Agenda
Technical Committee on Lightning Protection
First Draft Meeting
Fort Collins, CO
October 17 - 20, 2017

NFPA 780 SECOND DRAFT MEETING MINUTES
Technical Committee on Standard for the
Installation of Lightning Protection Systems
July 27 – 30, 2015
DoubleTree Hotel Charlotte Airport
Charlotte, NC

Figure 4.6.2.1 Air Terminal Height.

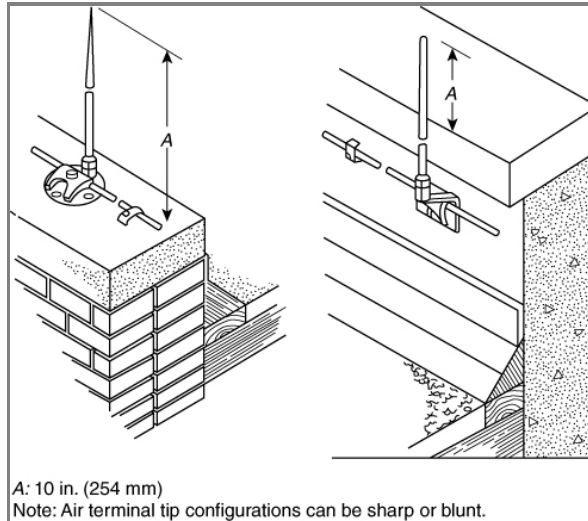
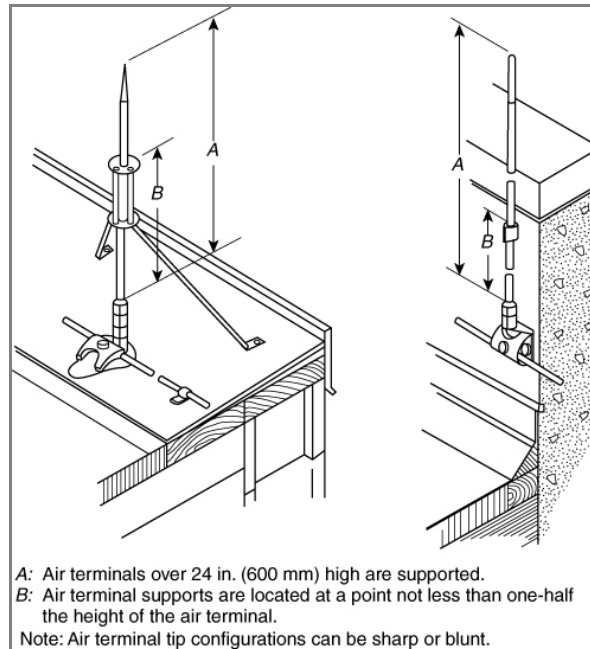
The appearances of air terminals currently installed vary. The air terminals drawn in Figure 4.6.2.1, 4.6.2.2.2 and 7.8.2 are not adequate to represent all existing air terminals. Therefore, a note needs to be added to prevent users to select and utilize air terminals only from the suggested drawing.

Note 2: The user may select the type of air terminals depending on the conditions of the site. However, the LPS shall be designed and installed in accordance with NFPA 780

Figure 4.6.2.2.2 Air Terminal Support.

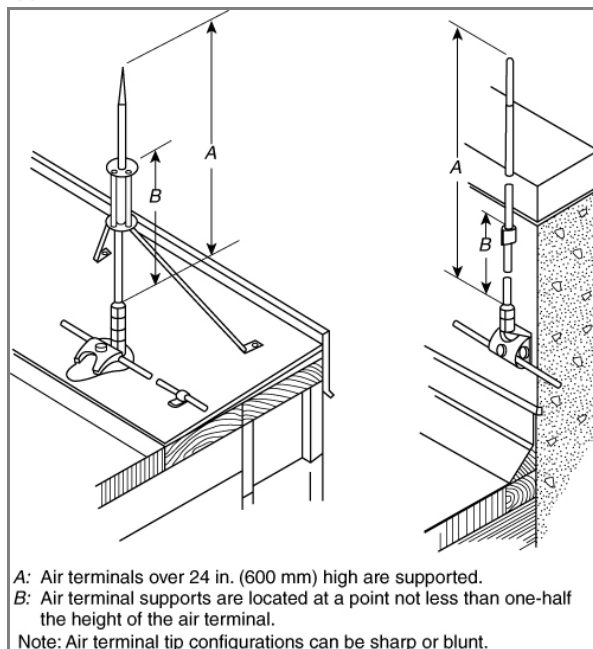
Allow an un-braced air terminal on a structure if it and its mounting base, as installed, is capable of withstanding a tipping force of 2.2 lbs (0.9979032 kg) per foot (0.3048 m) of unbraced elevation conductor length at its tip or alternately able to withstand a wind of 156 mph (0.3048 m/second) (category 5 hurricane). Most air terminals in these applications are installed on structural steel where the bracing requirement is downright comical. Add .2 and .3 to agree with the intent of 6.3.4.2 and 6.3.4.3.

) in height shall be supported at a point not less than one-half their height, as shown in Figure 4.6.2.2.2 ; except that an air terminal and base combination shall not require side bracing if it is installed on structural steel or concrete, and is capable of withstanding a tipping force of 2.2 lbs (0.9979032 kg) per foot (0.3048 m) of un-braced elevation conductor length at its tip or alternately able to withstand a wind of 156 mph (0.3048 m/second).

Figure 4.7.1.4 Protection Measures for Various Roof Types. (Drawings are top and end views of each roof type.)

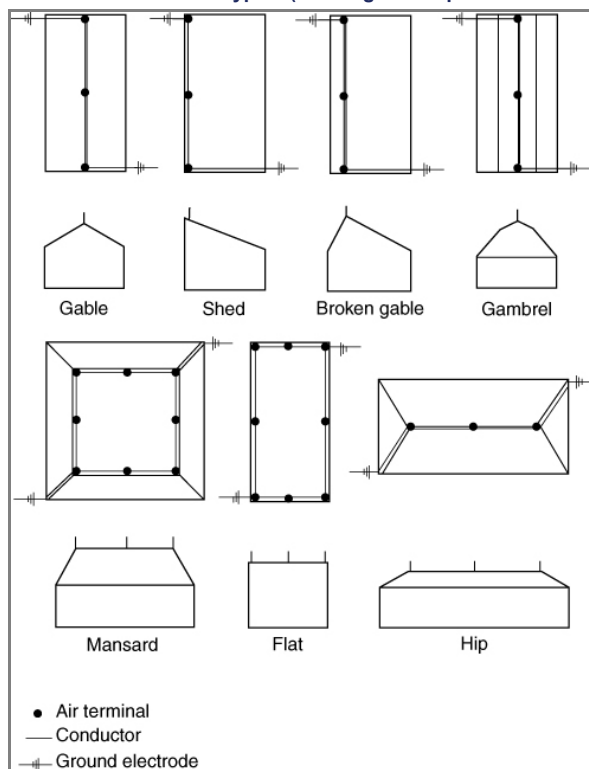
File Name	Description	Approved
Reference_12.docx	revised figure 4.7.1.4

Figure 4.7.2.1 Air Terminals on a Pitched Roof.

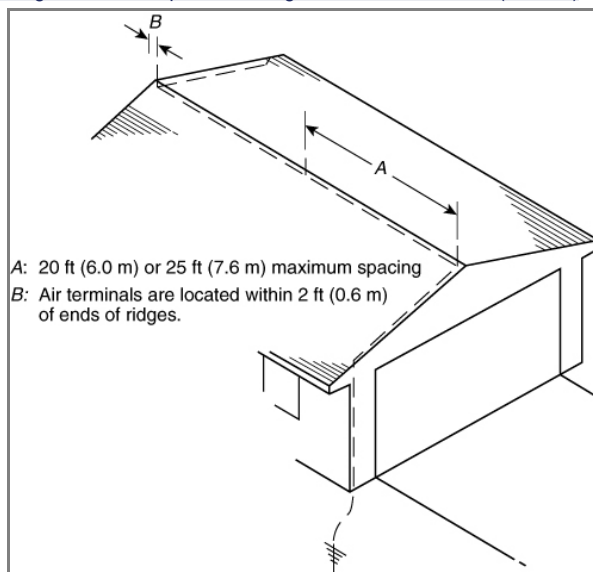
Note to NFPA Staff: Please change the vales expressed in Figure 4.7.2.1 B: to 24 in. (600mm)

Figure 4.7.2.1 Air Terminals on a Pitched Roof.

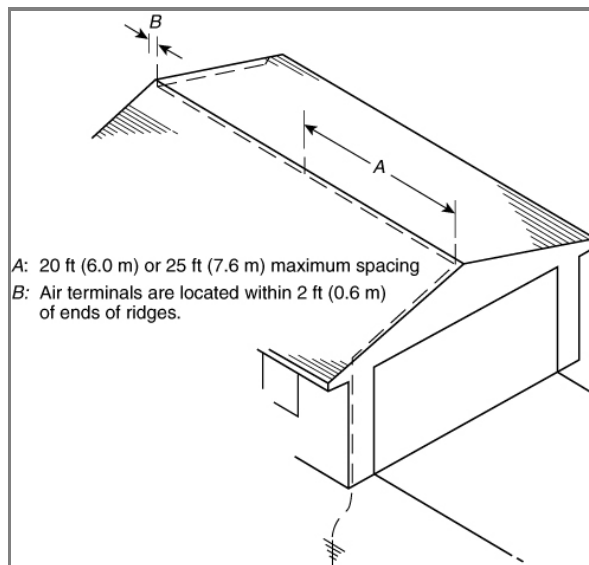
<u>File Name</u>	<u>Description</u>	<u>Approved</u>
Reference_12-1.docx	revise figure 4.7.2.1

Figure 4.7.3.2 Illustration of Tangent of Rolling Sphere Method.

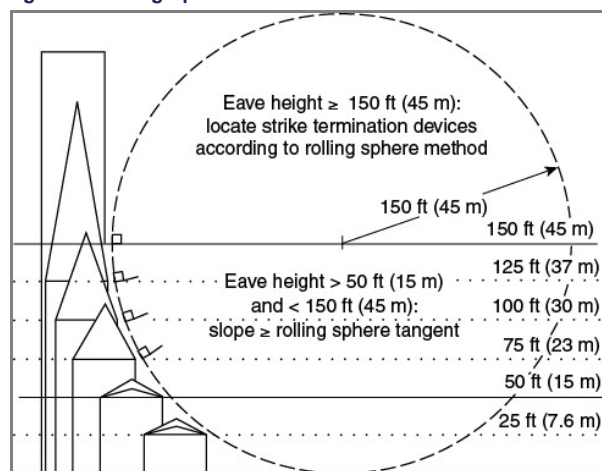
Bold or highlighted text needs to be explained in a better way. The comparison is too vague, or add an example to explain the concept.

Figure 4.7.5.1(a) Air Terminals on a Flat Roof.

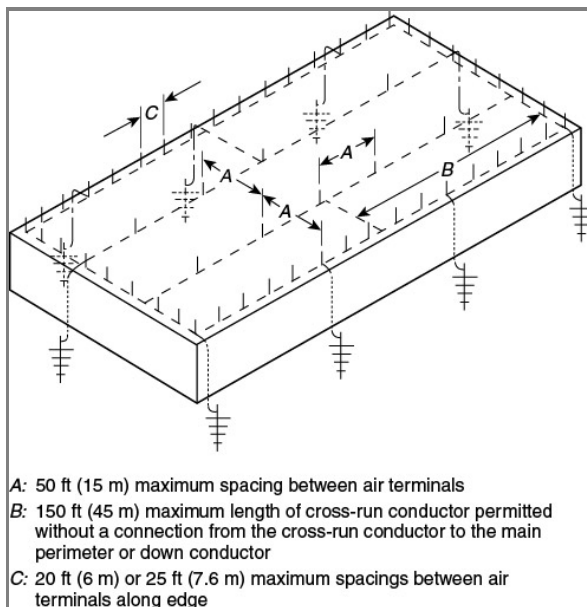
If the description of figure 4.7.5.1 (a) is correct, than the width of the building is 160 feet instead of 150 feet. (20 x 8 ea. (C spaces). Therefore the flat roof should have three cross runs instead of two like the picture. Needs to be corrected.

Figure 4.7.6.2 Flat or Gently Sloping Roof with an Irregular Perimeter.

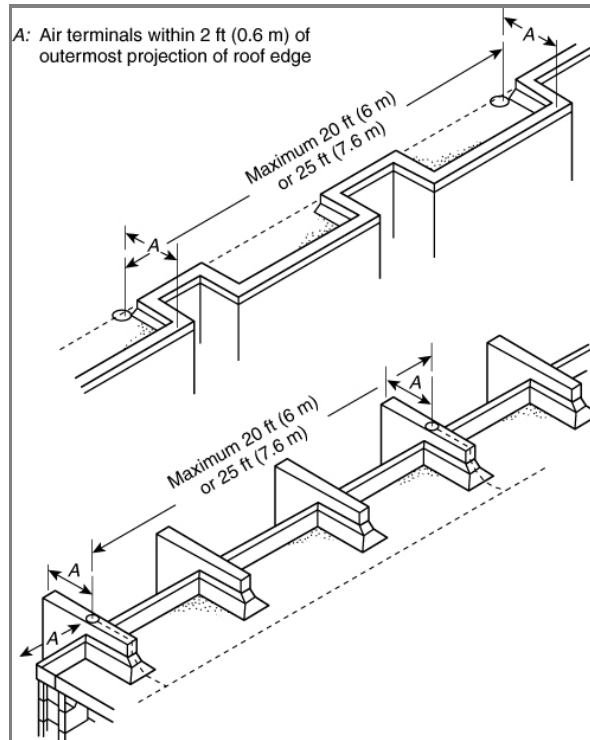
Note to NFPA Staff: Please change the values in Figure 4.7.6.2 A: to 4 in. (600mm)

The Editorial Task Group makes this change from feet to inches for accuracy and to maintain consistency throughout the standard

Figure 4.7.8.2 Strike Termination Devices Installed on Vertical Roof Members.

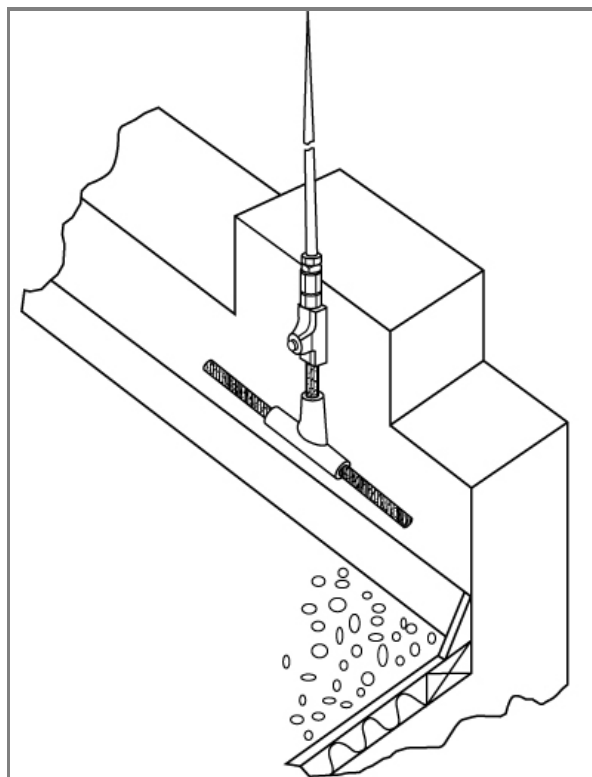
The appearances of air terminals currently installed vary. The air terminals drawn in Figure 4.6.2.1, 4.6.2.2 and 7.8.2 are not adequate to represent all existing air terminals. Therefore, a note needs to be added to prevent users to select and utilize air terminals only from the suggested drawing.

Note: Air terminal tip configurations can be sharp or blunt.

Figure 4.7.11.2 Air Terminals on a Chimney.

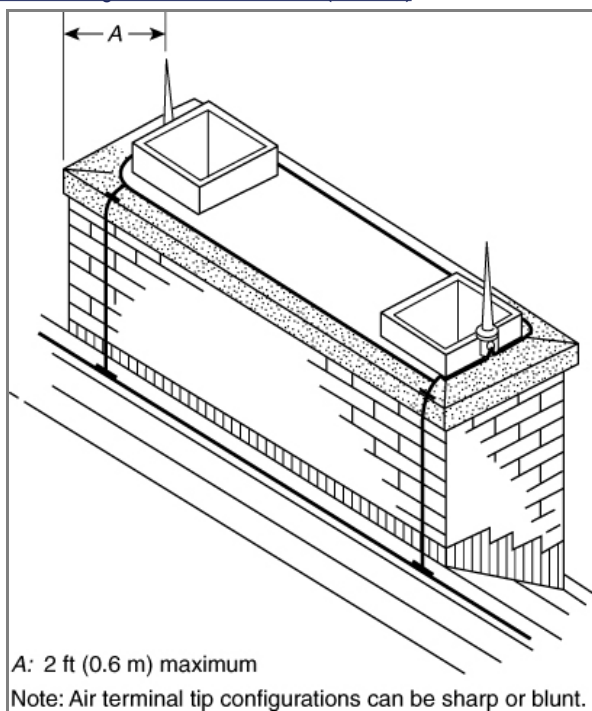
Note to NFPA Staff: Change the Value in Figure 4.7.11.2 A: to 24 in. (600 mm)

The Editorial Task Group makes the change from feet to inches for accuracy and to maintain consistency throughout the standard

FIGURE 4.9.1 (2)

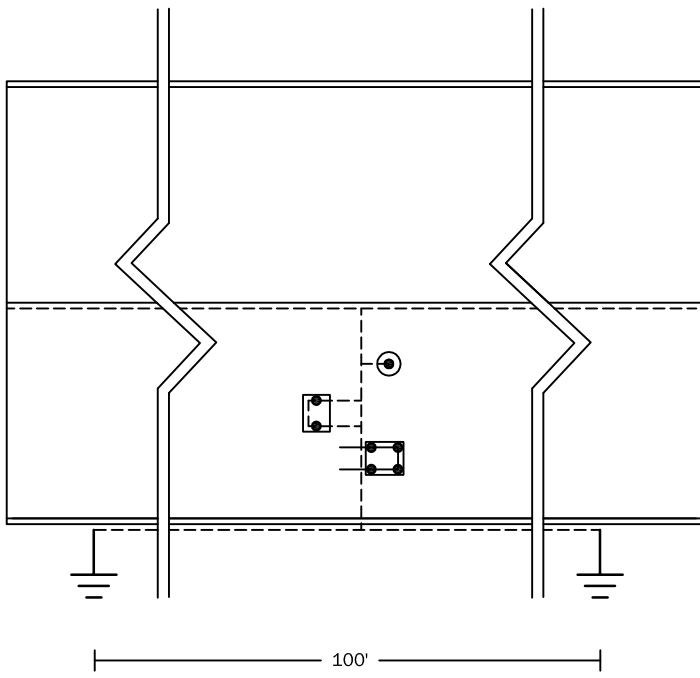
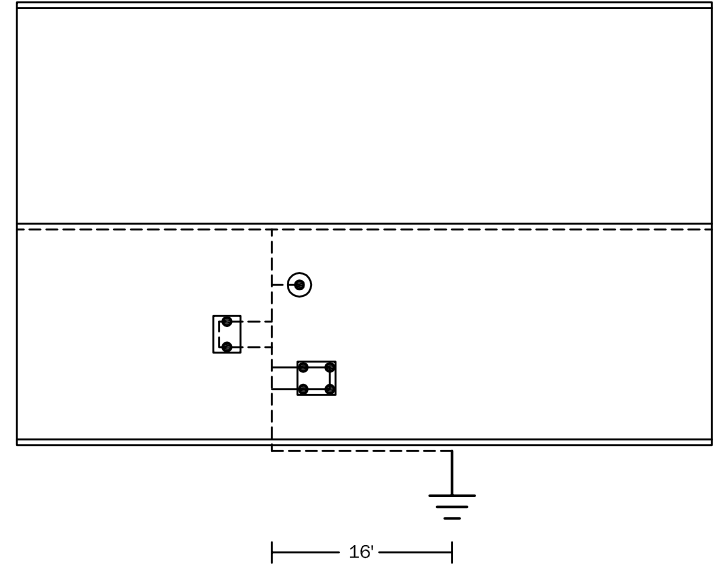
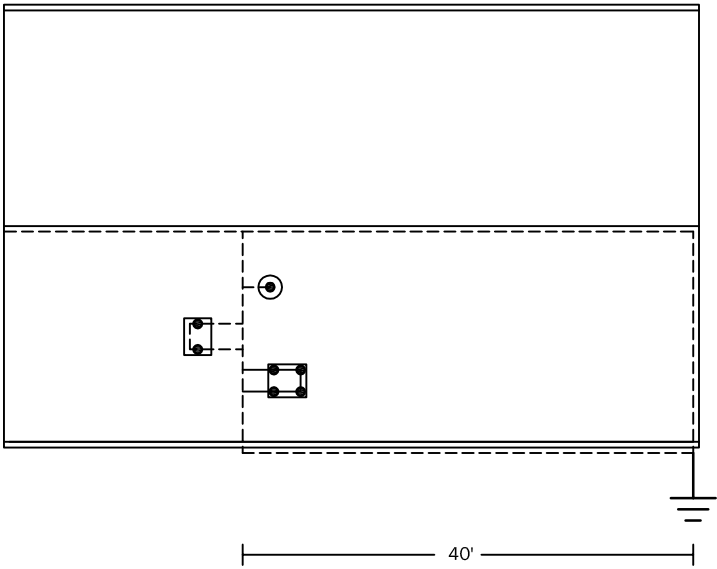
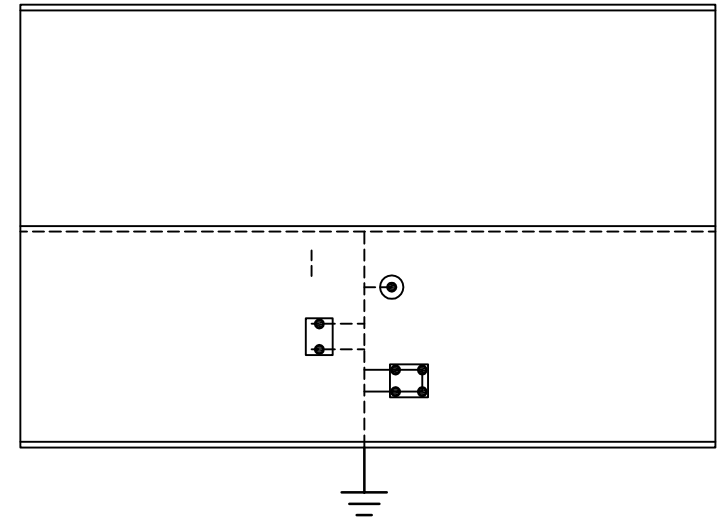
- (2) On a pitched roof, where the down hill side of the conductor run terminates to a horizontal run at the eave with at least 2 down leads attached to ground electrodes spaced within 100 ft. (30m) horizontally of each other as show in Figure 4.9.1 (2). INSERT NEW FIGURE

- (3) On a pitched roofs where the down hill side terminates to a ground electrode within 16 ft.(5m) horizontally from were the conductor meets the eave as shown in Figure 4.9.1 (3).INSERT NEW FIGURE

- (4) On a pitched roofs where the down hill side of conductor run is connected to another down conductor with in 40 ft. (12 m) horizontally from where the conductor meets the eave as shown Figure 4.9.1 (4). INSERT NEW FIGURE

- (5) On a pitched roof were the down hill side terminates directly to a ground electrode as shown in Figure 4.9.1 (5) INSERT NEW FIGURE

<u>File Name</u>	<u>Description</u>	<u>Approved</u>
Fig_4.9.1.pdf	New figure 4.9.1, taken from LPI 175 (2011) figure 21.

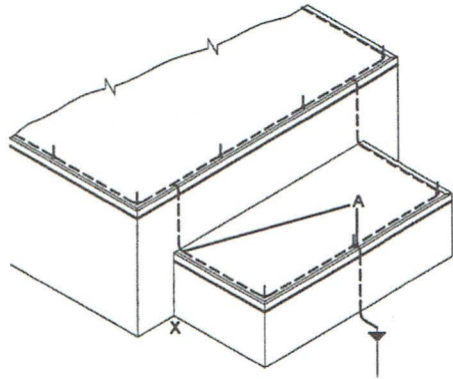
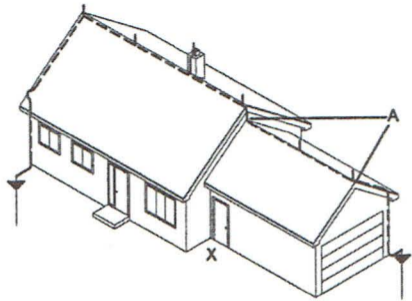
Clarifies the paragraph by adding a figure to explain the text.

Strike termination devices on a lower roof level that are interconnected by a conductor run from a higher roof level shall require only one horizontal or downward path to ground, provided the lower level roof conductor run does not exceed 40 ft (12 m), as shown in Figure 4.9.1.

Figure 4.9.4.2 Pockets.

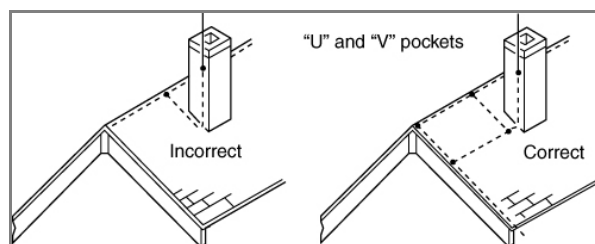
the figure does not show a good example.

<u>File Name</u>	<u>Description</u>	<u>Approved</u>
Fig_4.9.7.2.pdf	Figure 4.9.7.2 (proposed)

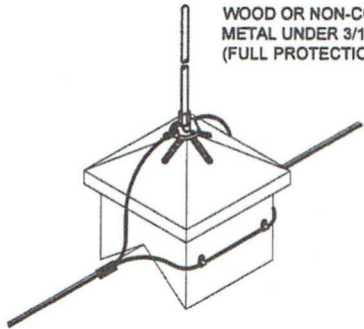
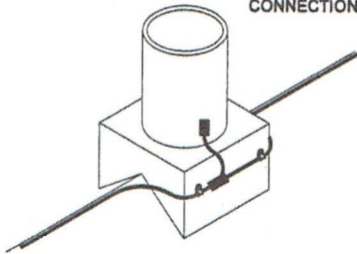
Conductors shall be coursed through or around obstructions (e.g., cupolas and ventilators) in a horizontal plane with the main conductor, as shown in Figure 4.9.7.2.

Add new figure after Figure 4.13.2.3.1

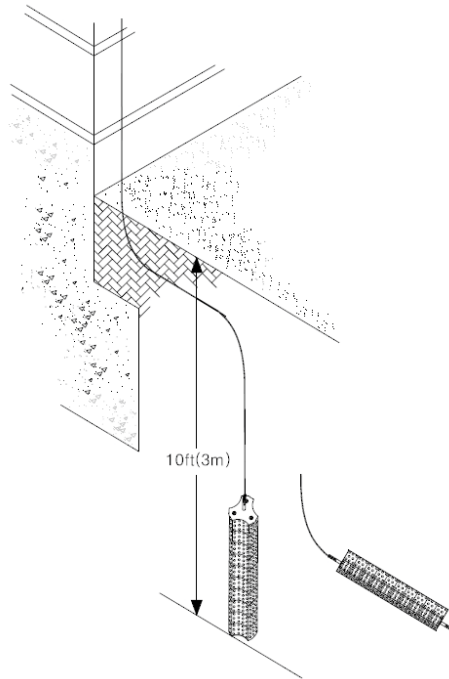
Add new picture about perlite carbon ground module

Figure 8.3.3.5.2 Connection of Metallic Masts to Ground Ring Electrode.

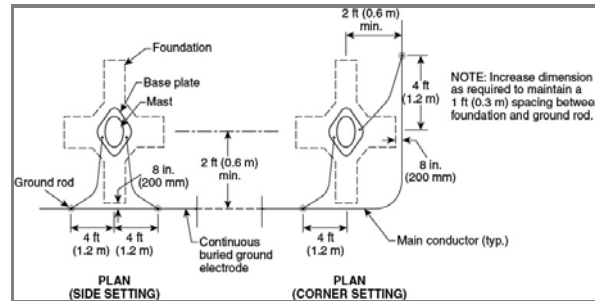
NOTE TO NFPA STAFF: Change the values in Figure 8.3.3.5.2 that are expressed as 2 ft. (0.6m) to 24 in. (600mm) typical of 2 locations. Change the SI value in the note to 1 ft. (300 mm)

Figure 11.4.2.6.2 Alternate Counterpoise Installation Method for Elevated Edge Light Fixtures Installed in Turf or Stabilized Soils and for Raceways or Cables Adjacent to the Full Strength Pavement Edge.

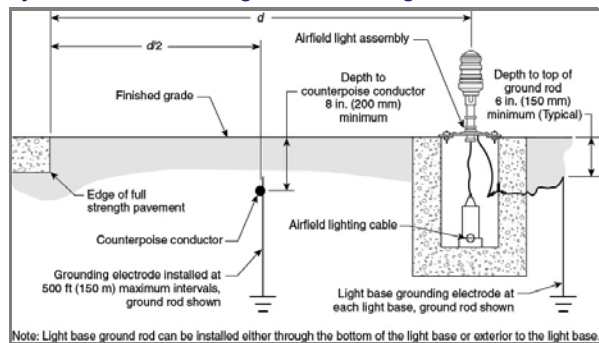
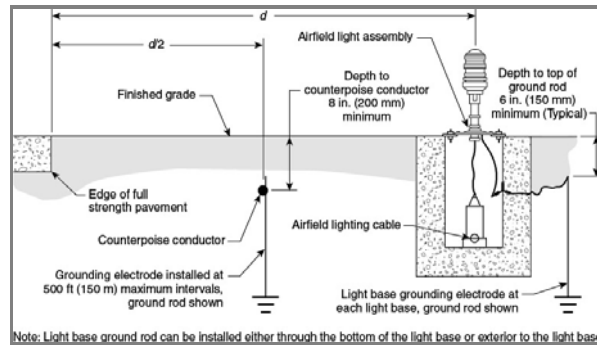
Figure 11.4.2.6.2 shows an elevated edge fixture. Fixtures installed in a turf or stabilized soil area would typically be an elevated edge light fixture.

As an alternate counterpoise installation method for elevated edge light fixtures installed in turf or stabilized soils and for raceways or cables adjacent to the full strength pavement edge, the counterpoise conductor shall be installed halfway between the pavement edge and the light base, mounting stake, raceway, or cable, as described in 11.4.2.6.2.1 through 11.4.2.6.2.2 and as shown in Figure 11.4.2.6.2.

Figure A.4.8.3.1 Zone of Protection Utilizing Rolling Sphere Method.

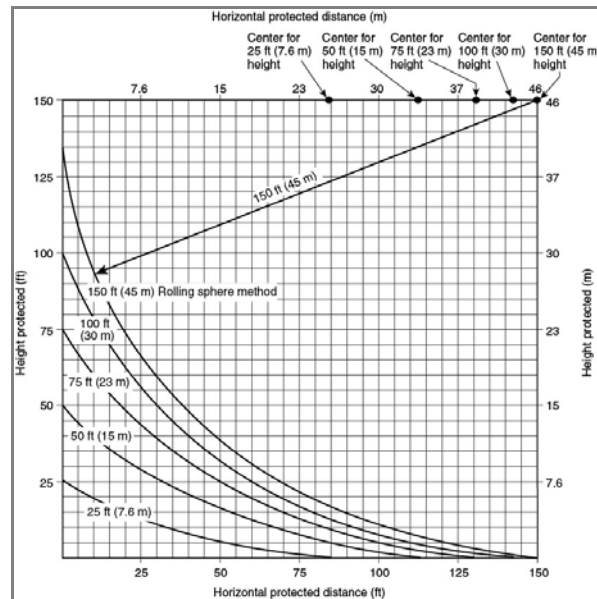
ATTENTION NFPA STAFF: Remove identification of the arcs from the body of the graph in Figure A.4.8.3.1 and change 46 in 2 places at the upper right hand corner to 45 in each of the cases.

Figure A.11.1.1(b) Isolation Method for Elevated Edge Lights Installed in Turf or Stabilized Soil.

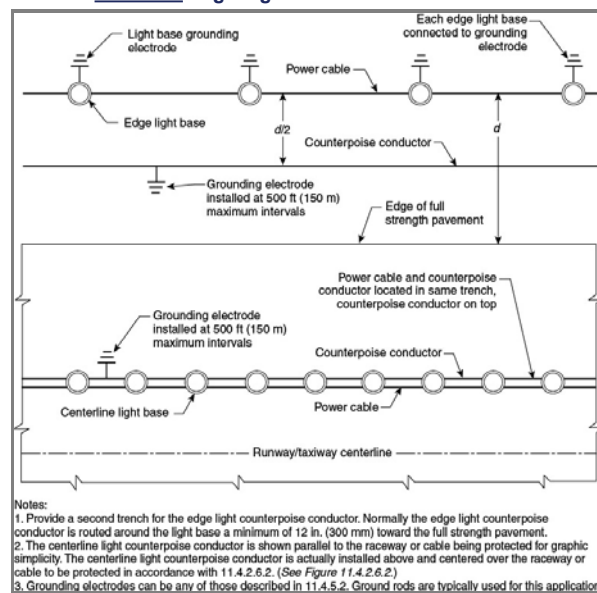
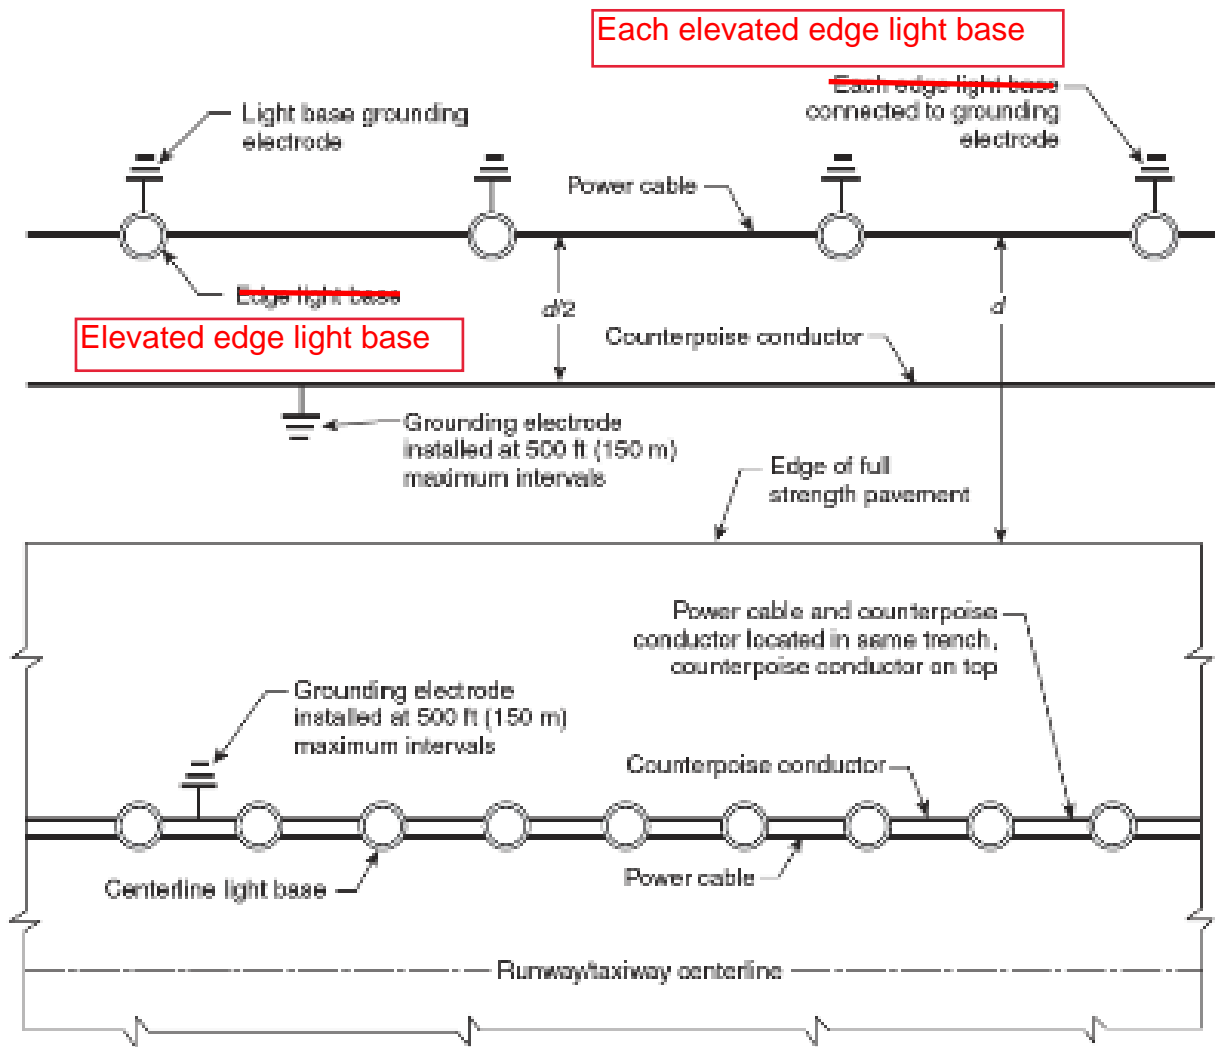
Figure 11.4.2.6.2 shows an elevated fixture. Figure A.11.1.1(b) provides a plan view of Figure 11.4.2.6.2. Fixtures installed in a turf or stabilized soil area would typically be an elevated edge light fixture. Revised text matches figure and typical installation practices.

Paragraph and figure number revision in Figure A.11.1.1(b) notes section provides corrected reference.

File Name	Description	Approved
Figure_A.11.1.1_b_.pdf	revised figure A.11.1.1(b)
